ORDINANCE NO. 1128

**AN ORDINANCE GRANTING A CHANGE OF ZONING
TO CERTAIN PROPERTY WITHIN THE CITY OF LANSING, KANSAS.**

Staff recommends **approval** of Case No. 2025-DEV-001, Delaware Ridge Rezone, at 24132 139th Street.

DELAWARE RIDGE

ZONING EXHIBIT

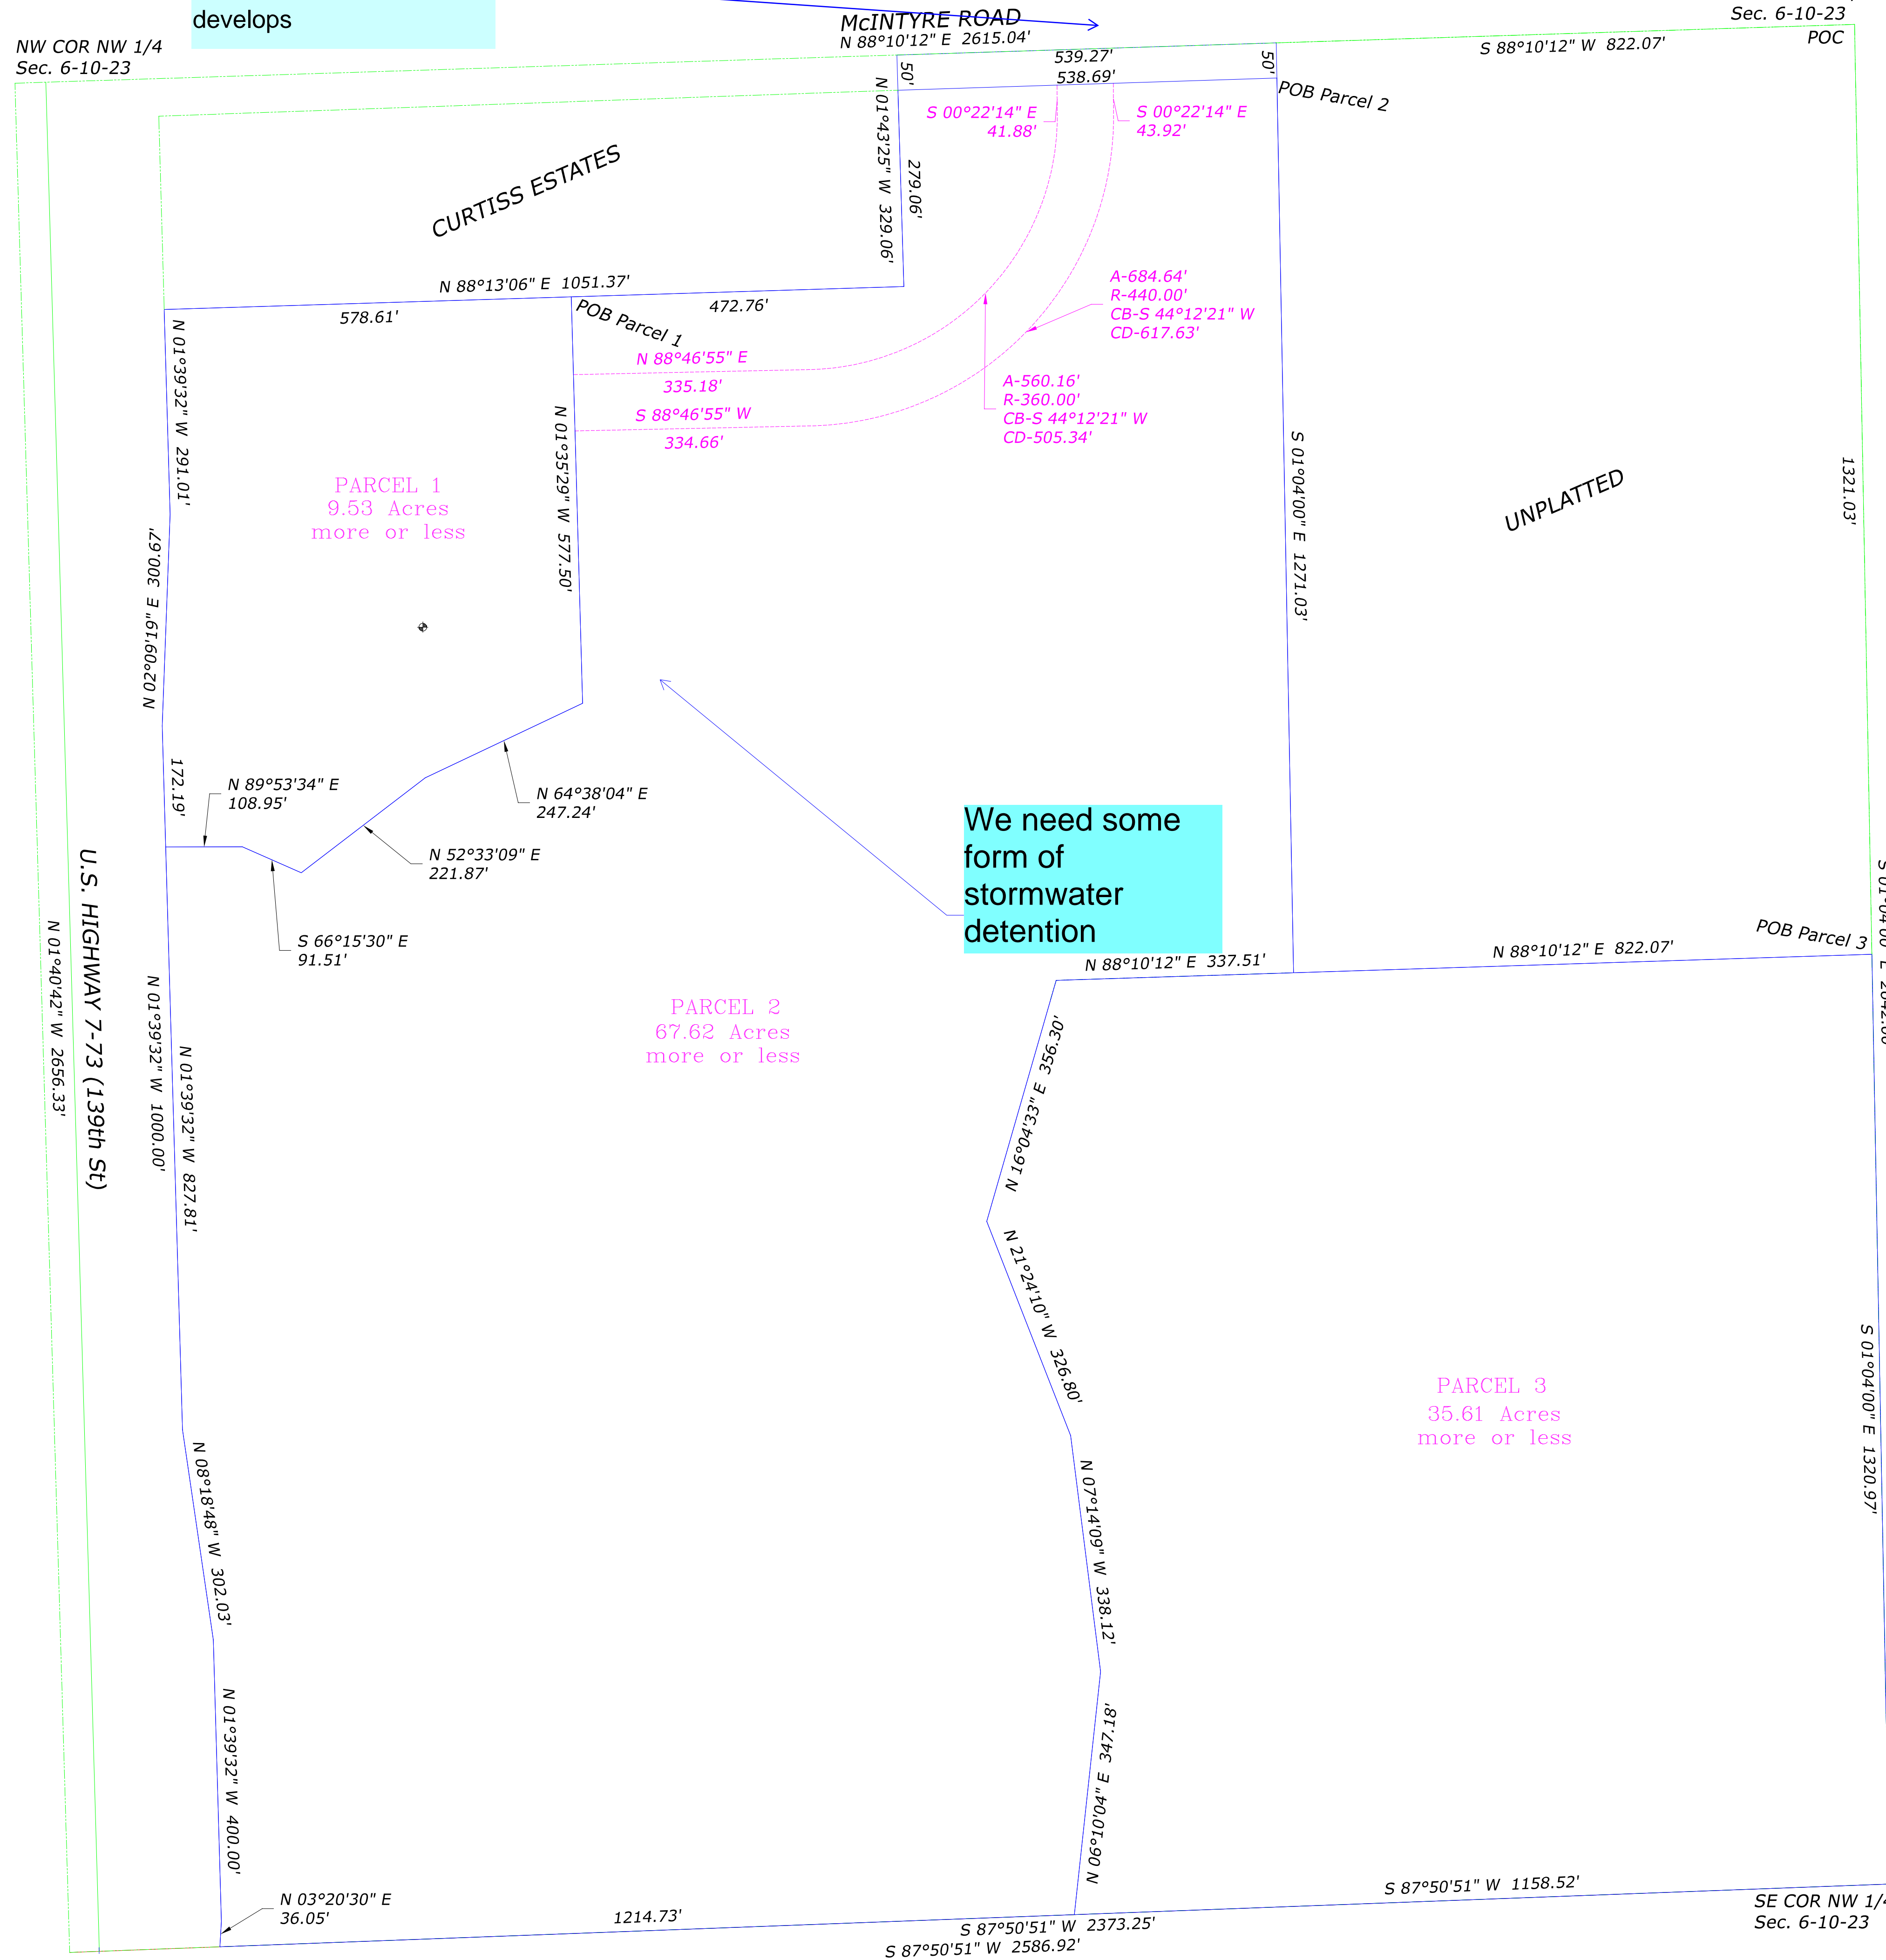
This access configuration is considered "temporary" until the further site develops

We need some form of stormwater detention

ARCHITECTURAL SITE
 PLAN

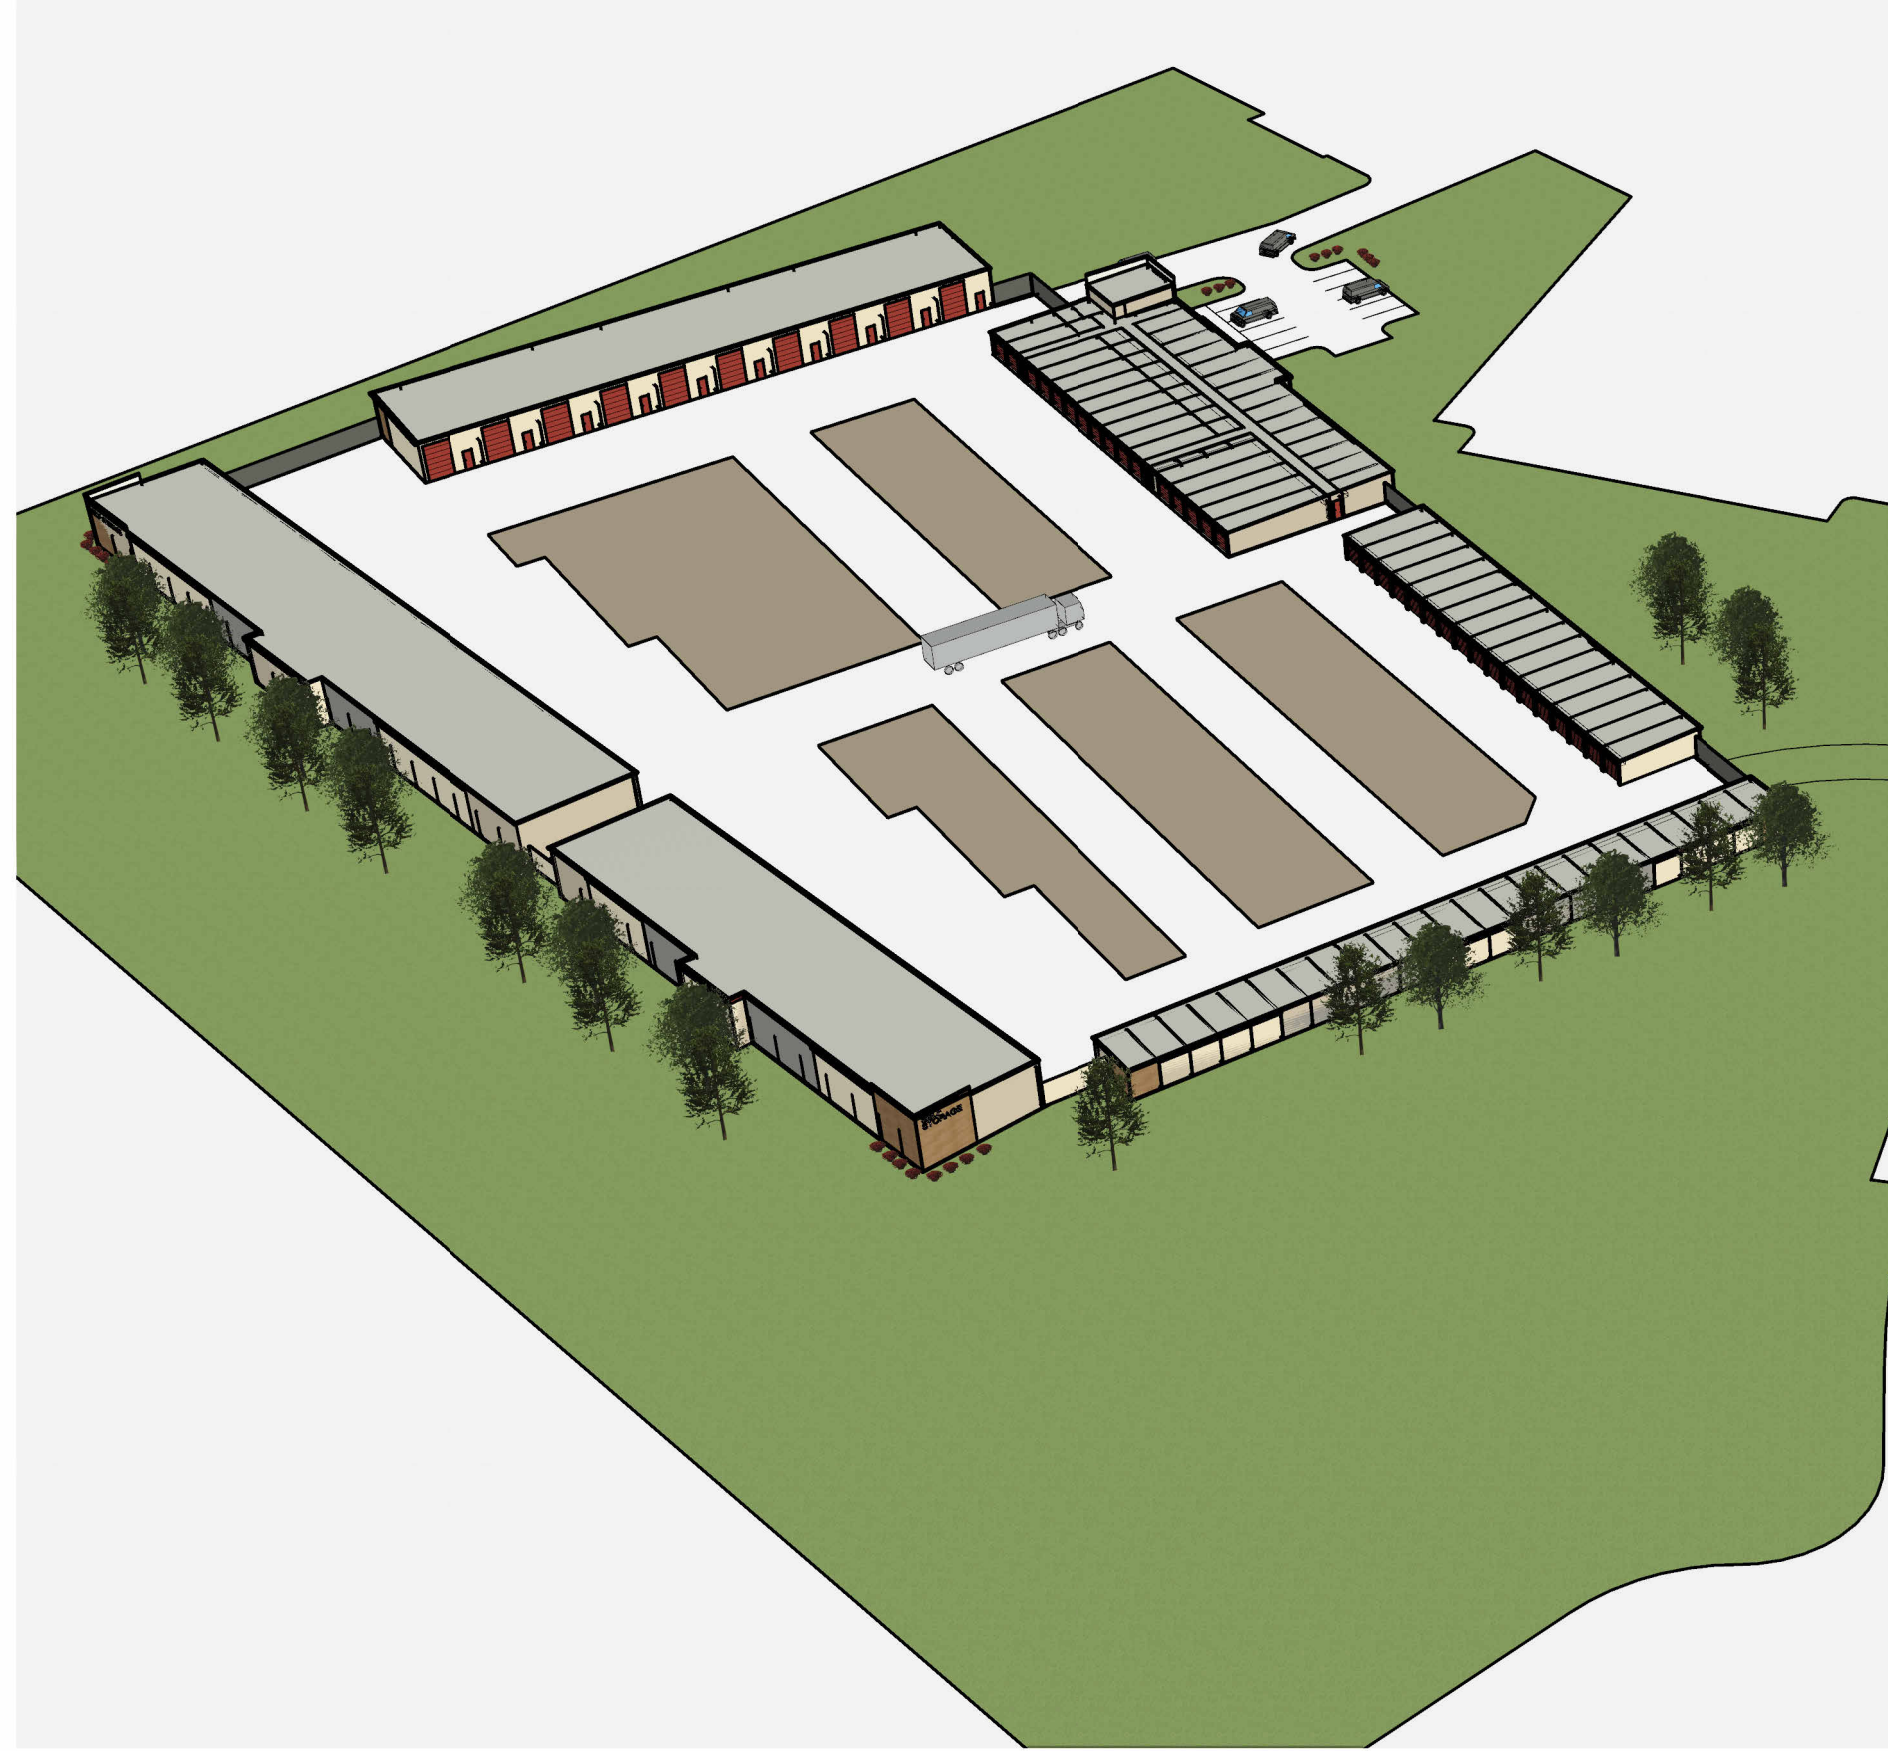
Stormwater Detention?
